CONSTRUCTION SUMMARY - PARTIAL ONLY
Legacy Hill - Trinigroup Development Inc.

LOT NUMBER	PHASE	HOUSE TYPE	REG. PLAN #		
35	1	Rose 5 Elev 1 (5 Bedroom)			
INV#	QTY	EXTRA / CHANGE

Rose 5 40th Lot

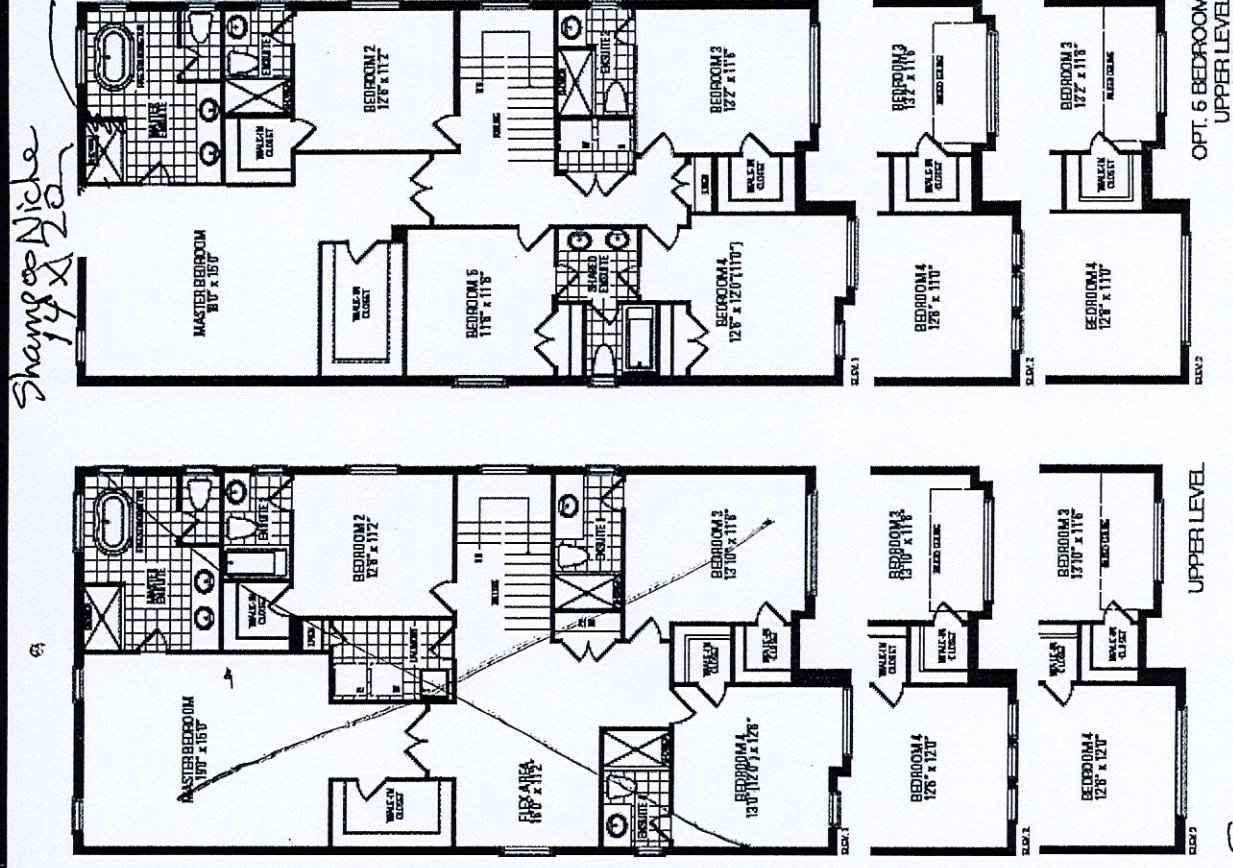
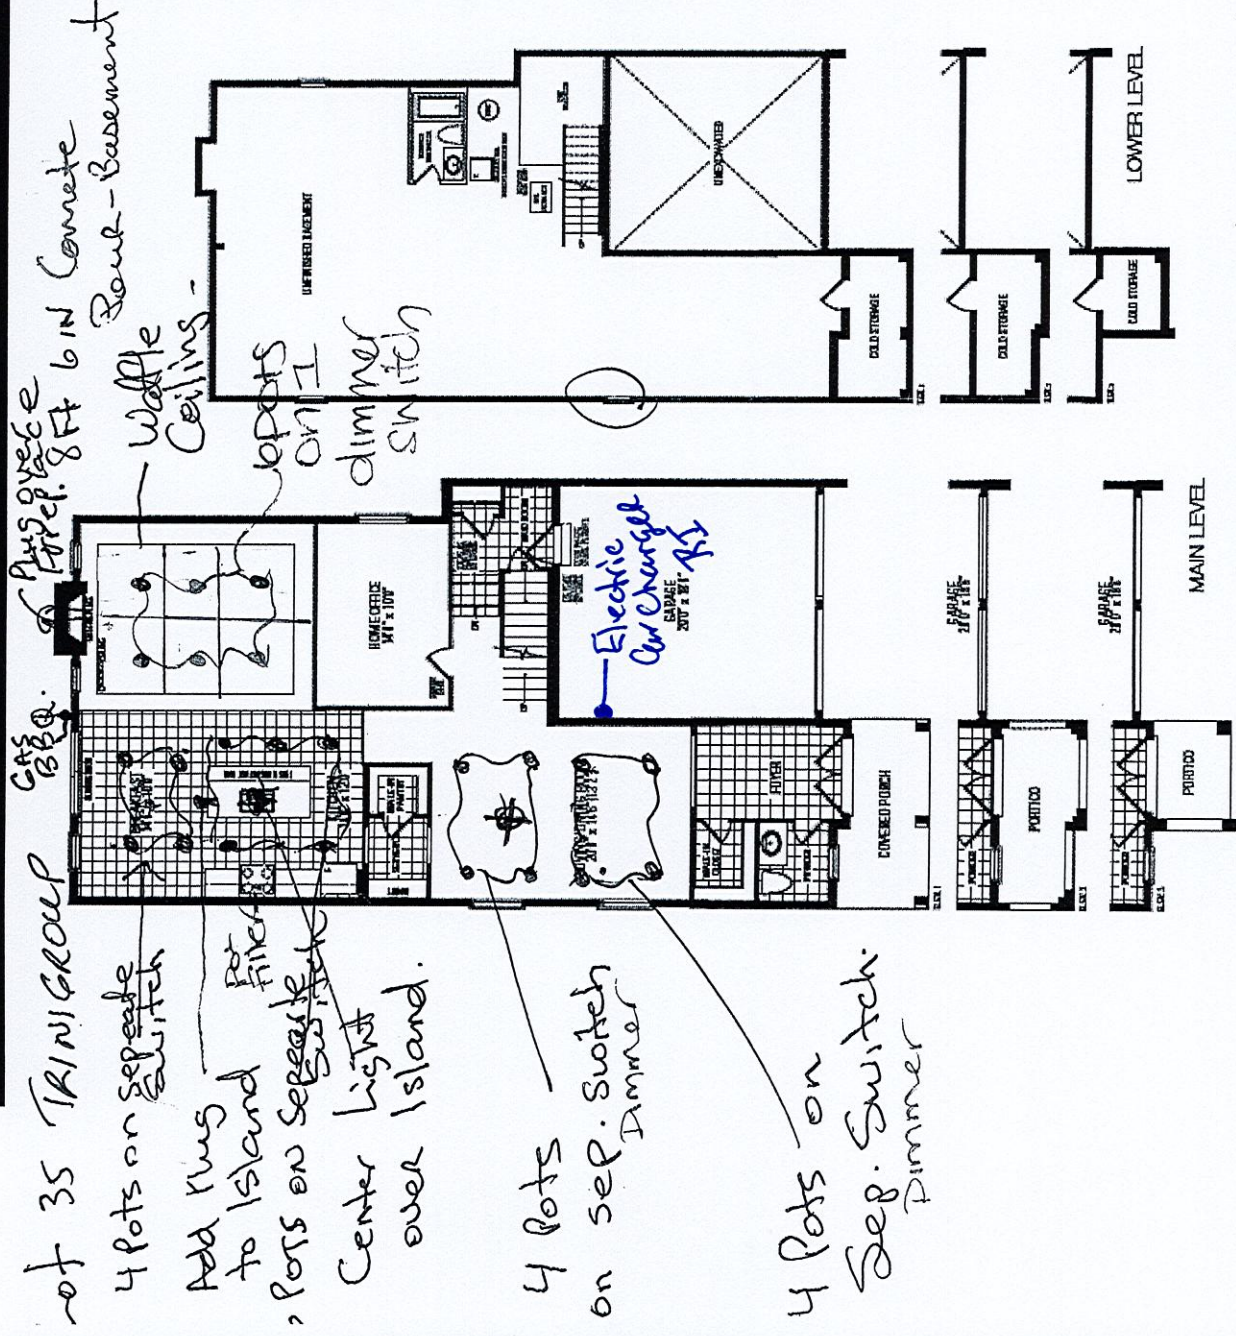
29,919 18Jul24	1 - ELECTRIC VEHICLE ROUGH-IN PROVISION ONLY FOR FUTURE ELECTRIC CAR (CONDUIT FROM BASEMENT INTO JUNCTION BOX IN GARAGE WITH PULL STRING, NO WIRE) Note:	★ ★ NEW ★ ★
29,821 16May24	1 - KITCHEN - PLUG - ELECTRICAL PLUG - ADD TO ISLAND Note:	
29,821 16May24	1 - PLUG - ELECTRICAL PLUG - TO BE INSTALLED OVER FIREPLACE Note:	
29,821 16May24	4 - FAN - BATHROOM EXHAUST FAN - ENERGY STAR 80 CFM - IN LIEU OF STANDARD FAN MASTER ENSUITE, ENSUITE 2, ENSUITE 3 & SHARED ENSUITE 4/5 Note:	
29,821 16May24	6 - FAMILY ROOM - POT LIGHT - LED - FIRST FLOOR INSTALLATION NoteDELETE STANDARD CEILING LIGHT	
29,821 16May24	4 - BREAKFAST AREA - POT LIGHT - LED - FIRST FLOOR INSTALLATION NoteSTANDARD LIGHT ON SEPARATE SWITCH	
29,821 16May24	6 - KITCHEN - POT LIGHT - LED - FIRST FLOOR INSTALLATION NoteSTANDARD LIGHT ON SEPARATE SWITCH	
29,821 16May24	1 - KITCHEN - RELOCATE STANDARD KITCHEN LIGHT TO BE CENTERED OVER ISLAND Note:

29,821 16May24	4 - DINING ROOM - POT LIGHT - LED - FIRST FLOOR INSTALLATION NoteSTANDARD LIGHT ON SEPARATE SWITCH	
29,821 16May24	4 - LIVING ROOM - POT LIGHT - LED - FIRST FLOOR INSTALLATION NoteSTANDARD LIGHT ON SEPARATE SWITCH	
29,821 16May24	3 - SWITCH - DIMMER SWITCH IN LIEU OF EXISTING SWITCH - PRICE IS EACH NoteFOR POT LIGHTS FAMILY ROOM, LIVING ROOM & DINING ROOM
